RECORD OF DECISION

**WESTERN AVENUE
WATER QUALITY ASSURANCE REVOLVING FUND SITE
AVONDALE AND GOODYEAR, ARIZONA**

June 18, 2018

RESPONSIVENESS SUMMARY TO PUBLIC COMMENTS AND QUESTIONS

**PCE CONCENTRATIONS
IN GROUNDWATER
SUBUNIT A**

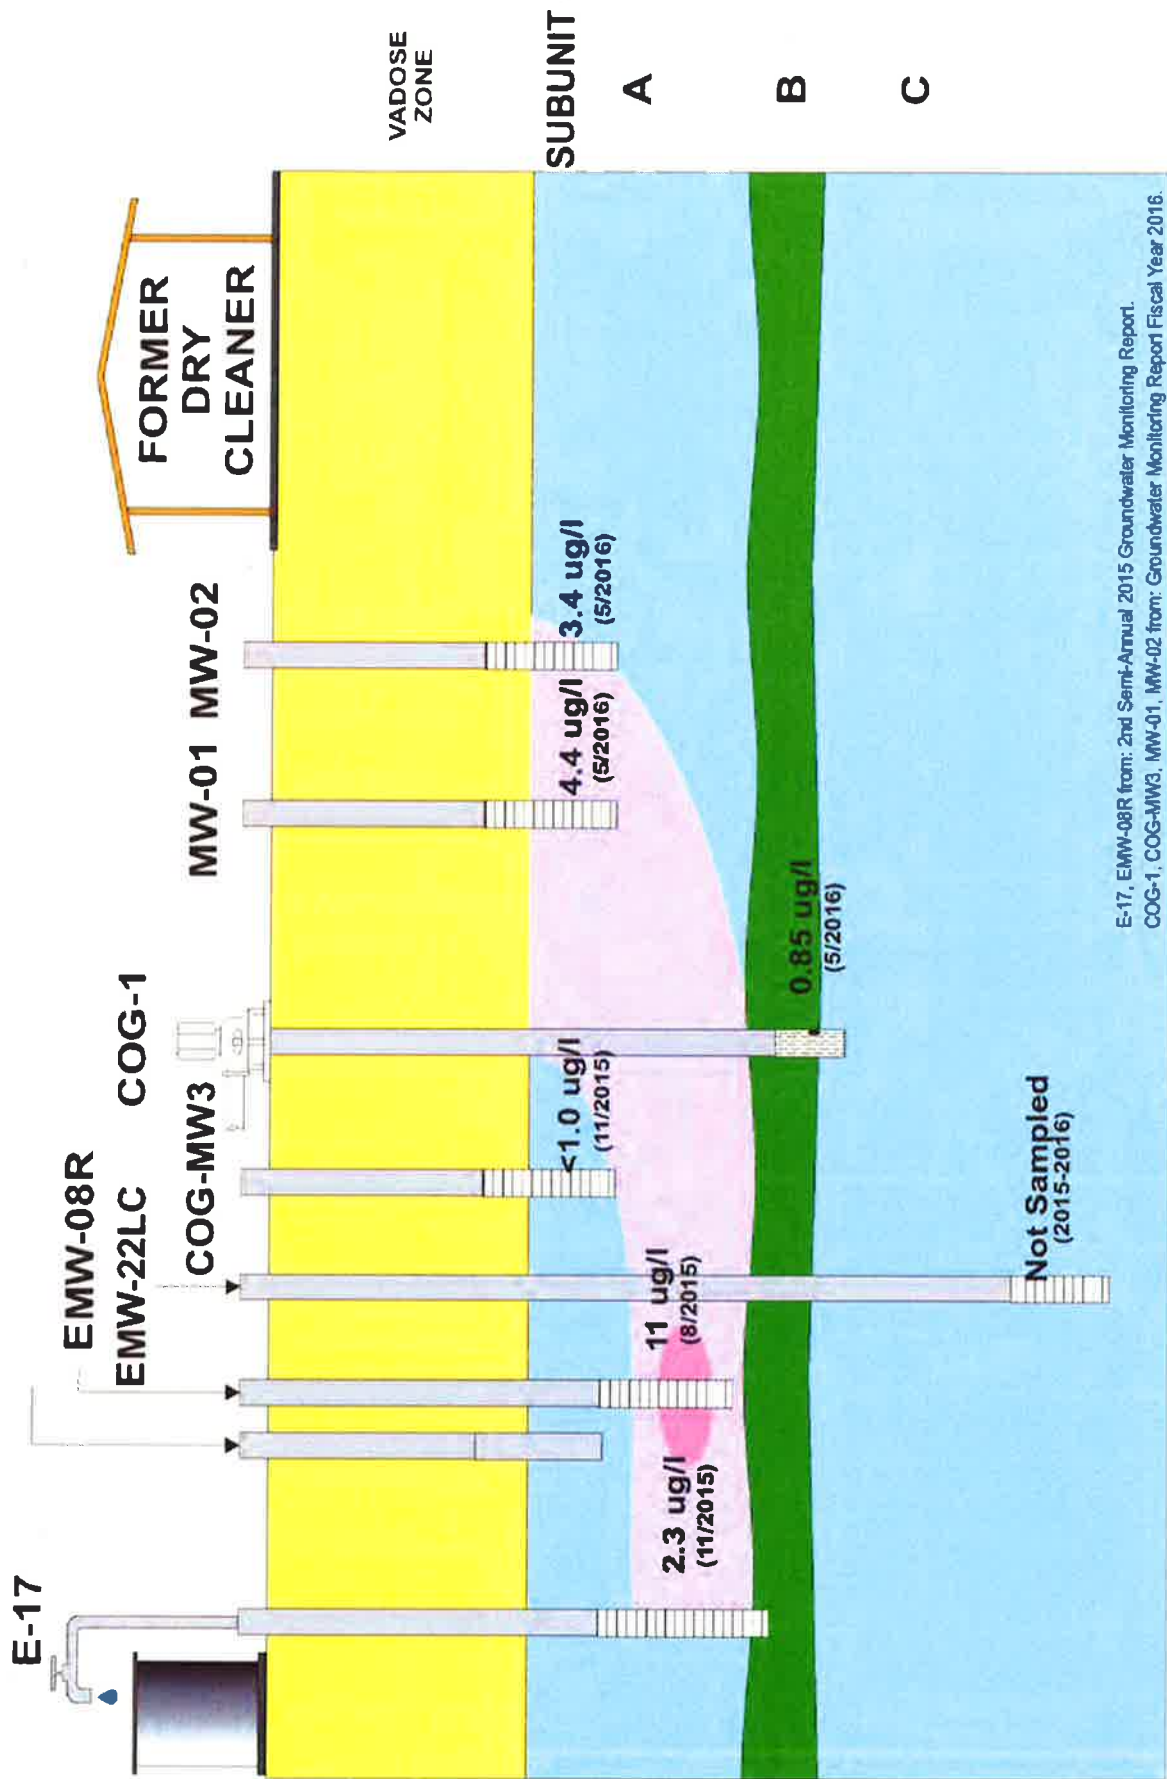
Quarles & Brady Comment 2. ...and also has not fully characterized the horizontal and vertical extent of the PCE contamination in the groundwater. Further, the existing monitor well network is not sufficient to accurately monitor and define the PCE plume. Accordingly, the Monitored Natural Attenuation ("MNA") remedial alternative selected in the PRAP is premature and additional site characterization and groundwater monitoring is needed before an appropriate remedial alternative can be selected and implemented."

ADEQ Response: Section 1.4, Figure 4, and Figure 5 of the ROD describe the nature and extent of contamination at the Site. The wells selected by the ROD for inclusion in the monitor well network for the Site are screened within the saturated aquifer and able to produce groundwater samples to judge the effectiveness of the selected remedy.
